## Hydrology of the Crimble Valley Catchment Area

The Crimble catchment area (Figure 1) includes the housing and employment draft site allocations PN17, PN18, PN19 and PN20 of the Harrogate Borough Council (HBC) Local Plan, and other major building proposals such as those for the Dunlopillo-Buttersyke Bar section of Green Belt.

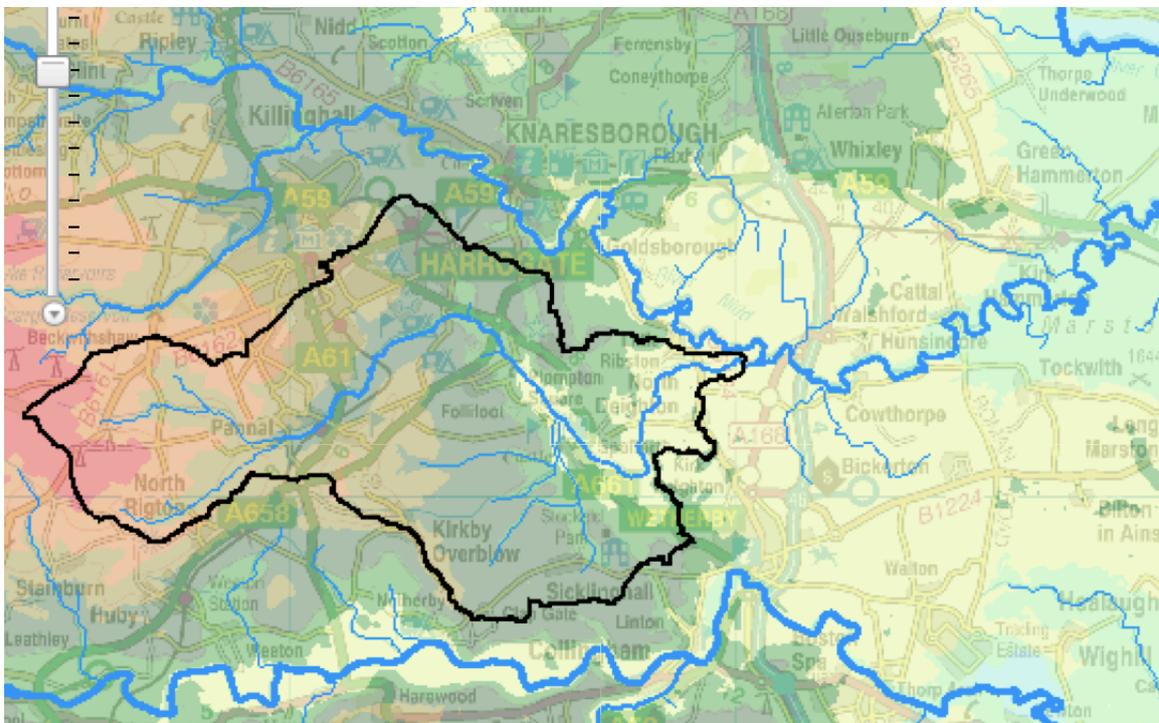
**The reasons listed below overwhelmingly indicate that the entire catchment basin should be excluded from the HBC Local Plan and from any HBC Planning considerations for major building development. These are topics which the HBC site selection procedures and Built and Natural Environment Site Assessments (BNESA, 2017) assessments have not yet considered with sufficient diligence. Indeed, the HBC proposals for the Pannal sites could be construed as failing to meet Planning soundness criteria for (a) hydrological aspects of environmental sustainability and (b) consistency with current national policy as it relates to flood resilience and flood management plans.**
